SERVICE BULLETIN

M-1000

1991 XLH VOLTAGE REGULATOR WIRE REROUTING AND 1991 XLH/ FX SERVICE MANUAL CORRECTION

Figure 1. Voltage Regulator Wire Rerouting

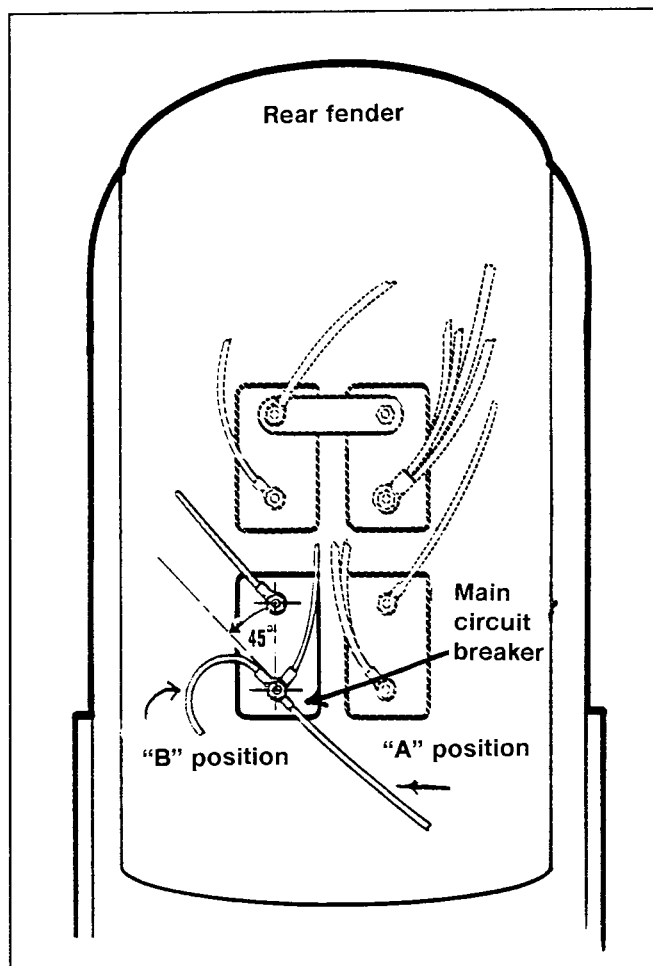
1991 XL assembly variations could cause contact between the black voltage regulator wire and the oil tank or transmission vent hose. The voltage regulator wire is connected to the silver stud on the main circuit breaker. See Figure 1. To correct this condition, please rotate the regulator wire from "A" position to the "B" position. If this is not done the connector may fail leading to regulator damage and loss of battery power.

Figure 2. Charging System Output Test

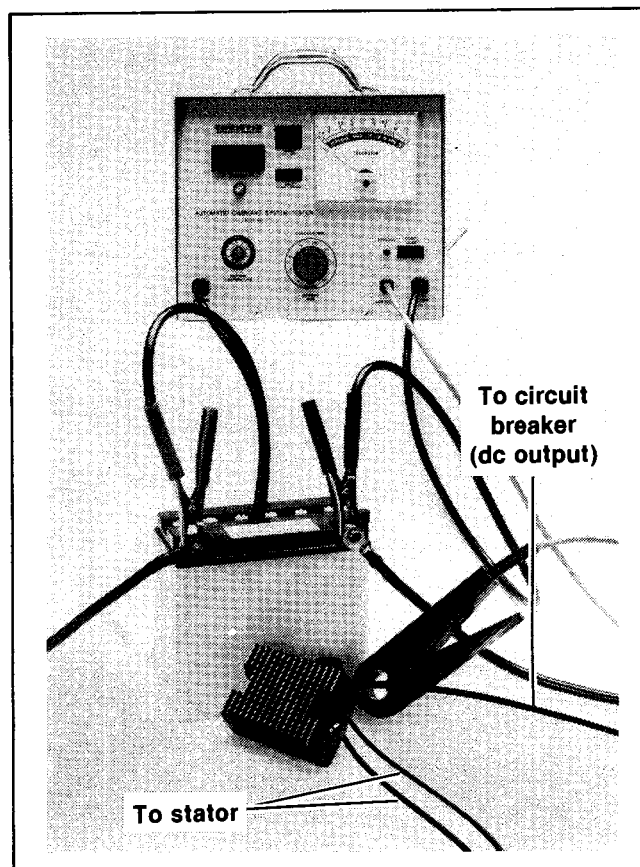
The illustrations Figure 7-14 on page 7-18 in Section 7 of the 1991 XLH Service Manual and Figure 8-12 on page 8-16 in section 8 of the 1991 FX Service Manual are incorrect. The illustrations show the induction probe clamped around all three wires, within the conduit, connected to the voltage regulator. This is wrong. See Figure 2. The induction probe should instead be clamped around the output wire (d.c. current) to the main circuit breaker only. The two wires to the alternator stator (a.c. current) are not a part of this test. Please mark your XLH and FX Service Manuals accordingly.

Figure 3. Trouble Shooting Ignition Module

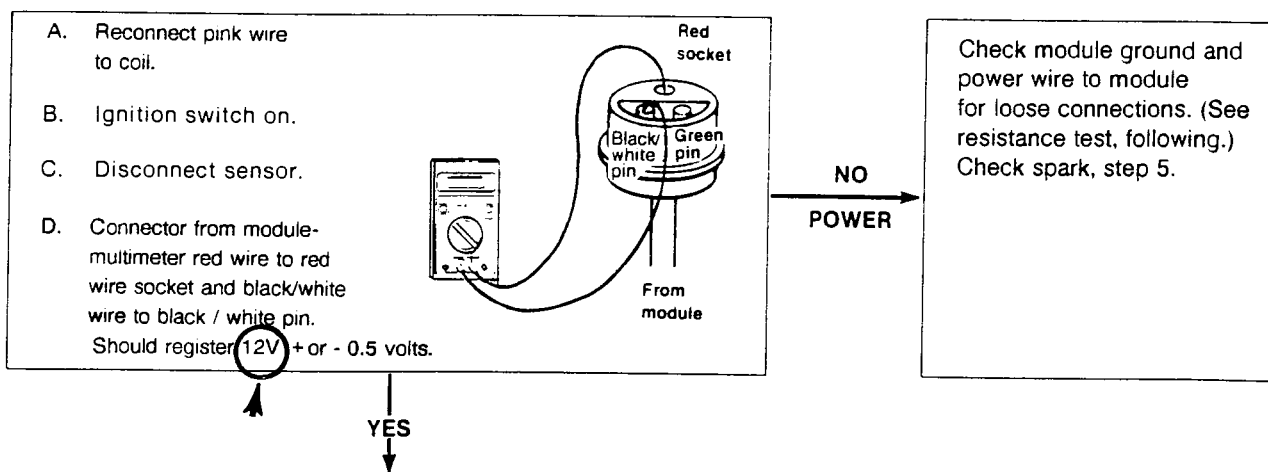
Refer to the trouble shooting chart on page 8-4 in the 1991 FX Service Manual and page 7-4 in the 1991 XLH Service Manual. See Figure 3. Under "D" in step 4 the reading at the meter should register 12 volts and not 5 volts as indicated in the Service Manuals. Please mark your manuals accordingly.

Figure 4. Resistance Test

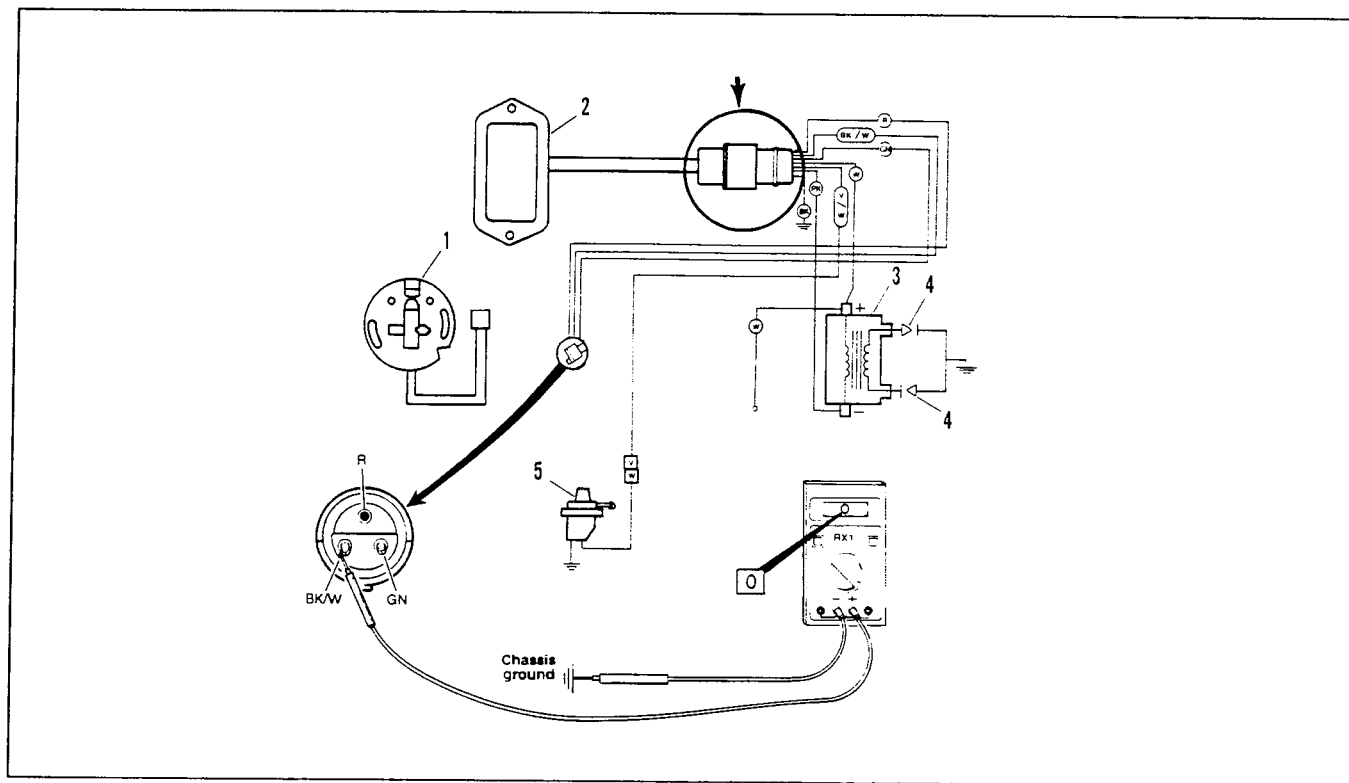
Refer to the Resistance Test Chart on page 8-6 in the 1991 FX Service Manual and page 7-6 in the 1991 XLH

Service Manual. See Figure 4. The illustration, in the Service Manuals, does not show the new ignition module 7 pin connector. The ignition module on all 1991 models can be detached, electrically, by separating the 7-pin connector. Please mark your manuals accordingly.
